Petition Number: #2022-020

From: Jake Carpenter, PE Reviewer: Kevin Parker

### **Transportation Summary**

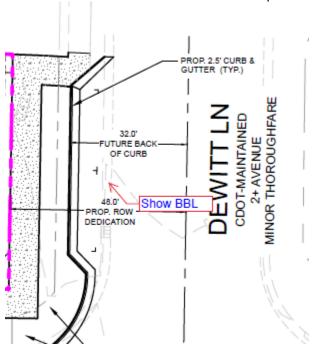
2. Revise the site plan and conditional note(s) by shifting the proposed driveway, on Freeland Lane, away from the crosswalk to be constructed by LDUTODTR-2021-00004.

3. Revise the site plan and conditional note(s) to reverse the direction of the proposed one-way driveway and internal street network to provide the egress movement on Ellenwood Place and the ingress movement on Freeland Lane.
